VILLAGE OF ESTERO
PLANNING ZONING AND DESIGN BOARD MEETING
PACKET
DECEMBER 9, 2025, 04:30 PM

- a. Chick-fil-A -- Development Order (DOS2025-E005) (District 5) 20320 Grande Oak Shoppes Drive, located on the northeast corner of Ben Hill Griffin Parkway and Corkscrew Road**

Planning Zoning and Design Board Staff Report

PROJECT NAME
Chick-fil-A / Ben Hill Griffin Parkway & Corkscrew Road
CASE NUMBER
DOS2025-E005
MEETING DATE
December 9, 2025
REQUEST
Applicant requests a development order for a proposed 5,695sf Chick-fil-A restaurant to be constructed at the site of the former Perkins restaurant at The Shoppes at Grande Oak
APPLICANT
Getra Sanders (Real Estate Manager, Chick-fil-A); Charles Krebs, PE authorized representative
LOCATION
20320 Grande Oak Shoppes Blvd
PROPERTY SIZE
2.05± acres
ZONING
MPD (Mixed Use Planned Development) with Corkscrew Road overlay. Parcel is part of Timberland & Tiburon DRI
PUBLIC INFORMATION MEETING DATES
The PZDB Public Information Meeting was held on June 10, 2025

A301 | OPTION 1
EXTERIOR ELEVATIONS

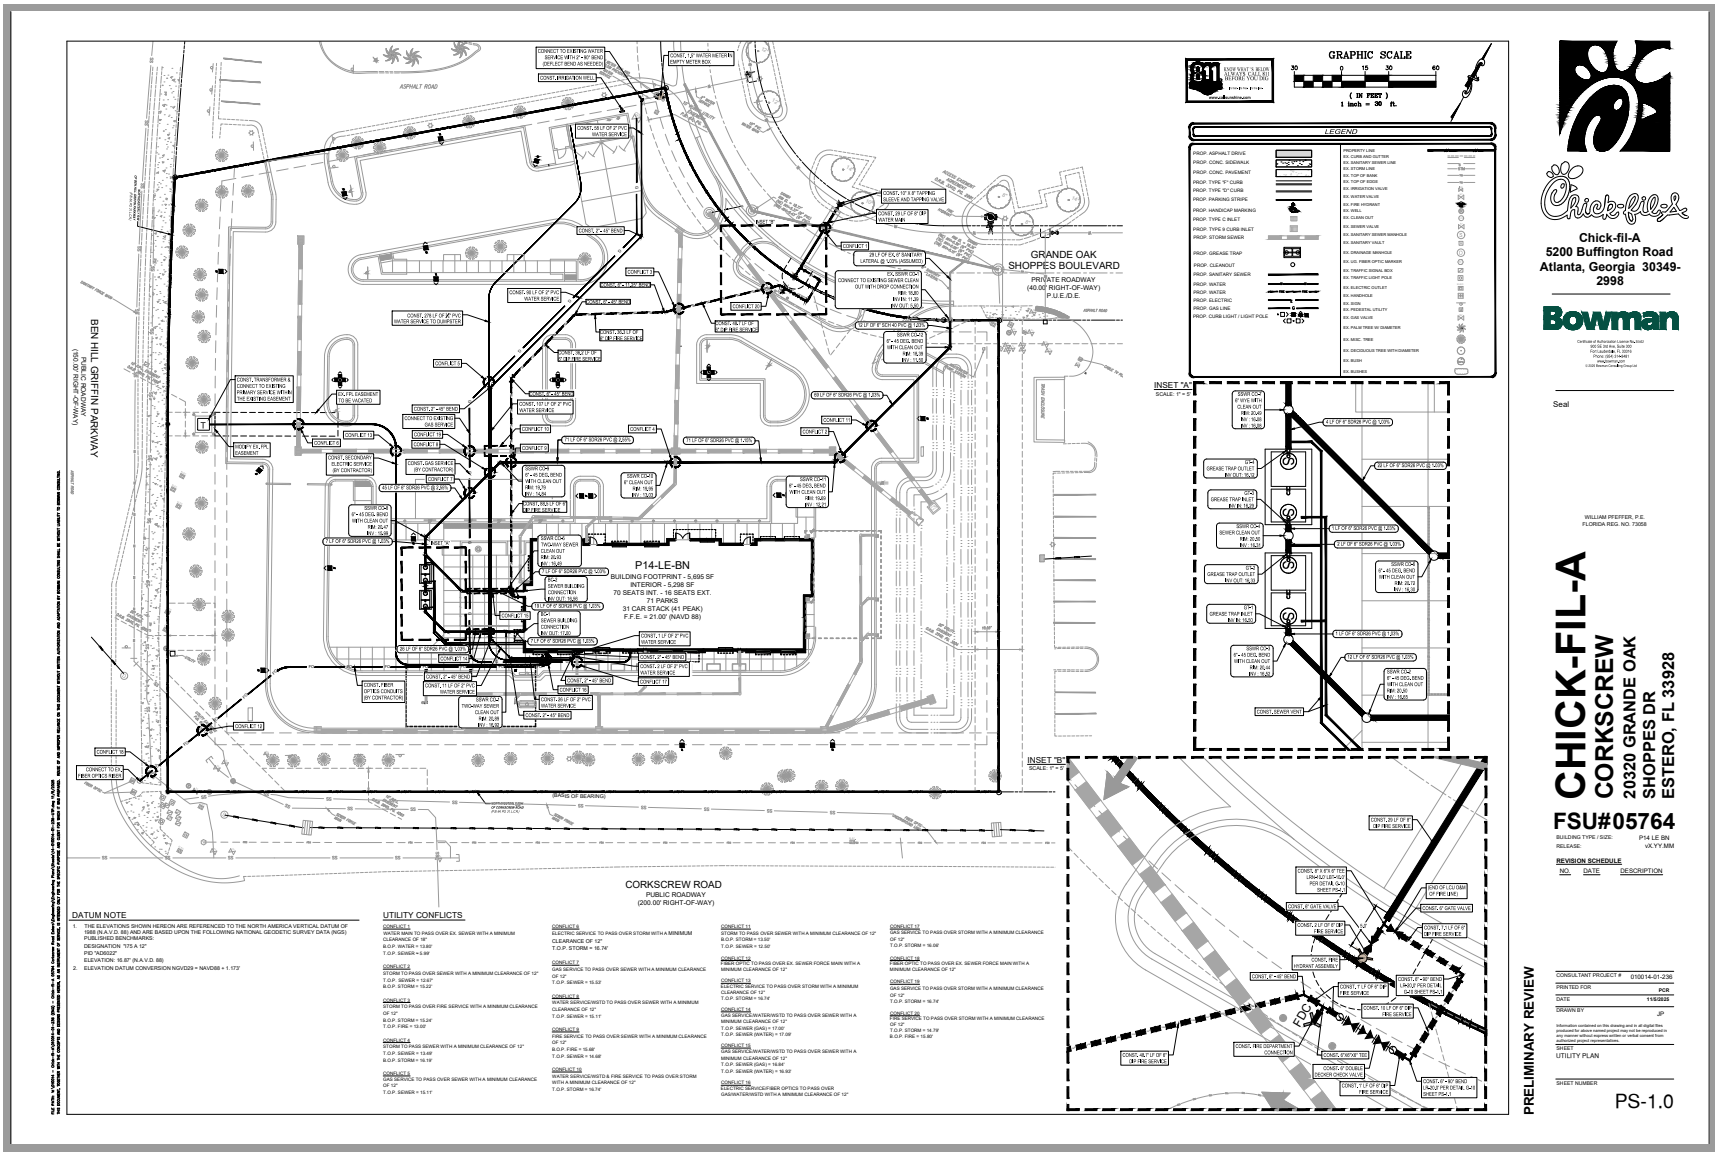
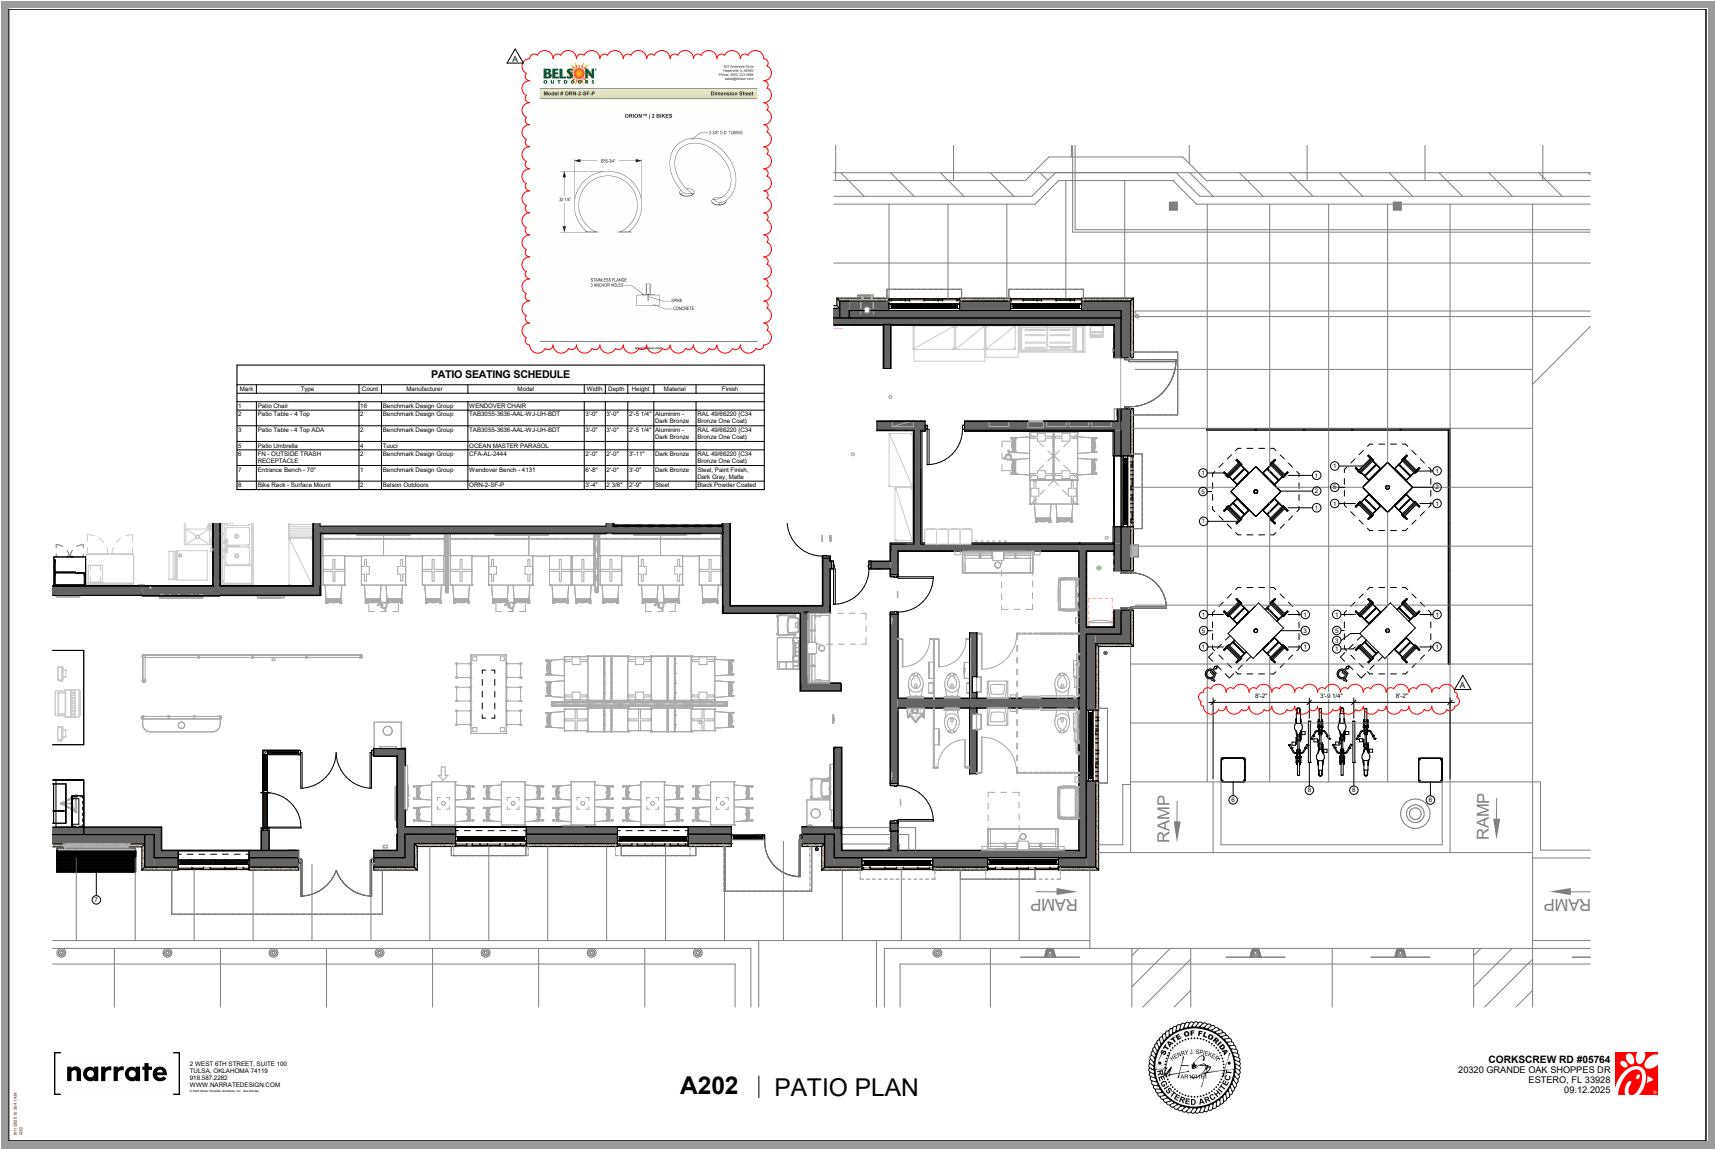
6:02:36PM >>Barry Jones: SHE WANTS VERY SPECIFIC DIRECTION IF THAT'S
6:02:39PM GOING TO BE THE CASE.
6:02:40PM CAN I BRING UP ONE MORE QUESTION ON THIS EXTERIOR ELEVATION
6:02:47PM WEST?

6:02:47PM THERE WAS AN ELEVATED SIDE OF THAT BUILDING THAT HAD A PANEL
6:02:53PM OF BLANK PANELS THERE.
6:02:55PM I'LL SHOW YOU WHAT I'M LOOKING AT HERE, AND MAYBE THAT'S

6:04:17PM >>Jim Wallace: I THOUGHT BARRY'S QUESTION WAS MORE COULD
 6:04:21PM PART OF THE WALL BE IN AUTUMN WHEAT, NOT ALL PEARL?
 6:04:26PM >>Michael Sheeley: WHEN YOU LOOK AT THE BUILDING IN

6:04:49PM >>Barry Jones: THAT FACE DOESN'T LOOK NEARLY AS LARGE AS --
 6:04:53PM >>Michael Sheeley: ELEVATIONS ARE DECEIVING THAT WAY.
 6:04:57PM >> TO THE QUESTION ABOUT CHANGING OR MODULATING THE COLOR,

6:03:25PM UP ALL THAT BLANK SPACE?
6:03:29PM >> ACTUALLY, YOU CAN SEE THERE ARE TWO PLANES.
6:03:32PM ONE IN FRONT OF THE OTHER.
6:03:33PM SO IT'S NOT JUST A FLAT WALL.

6:05:13PM INTERIOR PORTIONS, THEN THAT'S WHERE THAT COLOR BLOCKING IS
 6:05:17PM HAPPENING.
 6:05:17PM LOOKING AT IT IN PLAN, IF I CAN GO BACK THERE, THAT'S THIS

SHEET
SITE PLAN

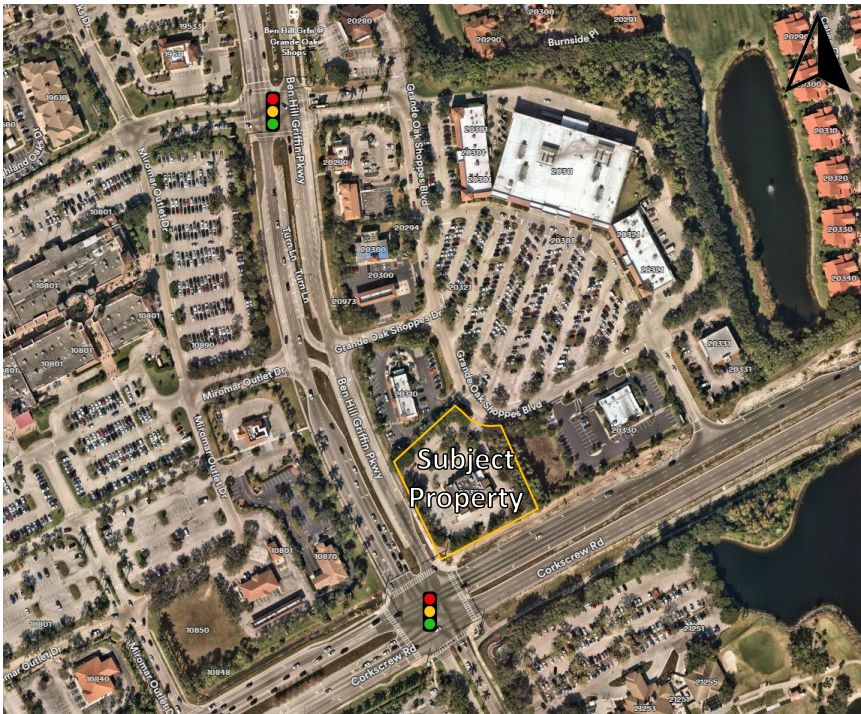
5:17:28PM >>Barry Jones: I'M SEEING IT NOW ON THE SITE PLAN, A LITTLE
5:17:33PM DASH LINE, THOSE ARE FREE-STANDING STRUCTURES OR THE ONE FOR
5:17:36PM FOOD DELIVERIES PHYSICALLY ATTACHED?
5:17:43PM >> THE ORDER POINT.

5:18:19PM >>Jim Wallace: WHY ARE THEY NOT ON THE SITE PLAN?
5:18:22PM >>Barry Jones: THEY ARE DASHED LINES ON THE SITE PLAN, JIM.
5:18:25PM THEY ARE NOT IN THE AUXILIARY.
5:18:31PM >>Jim Wallace: OH, YEAH, I SEE THEM.
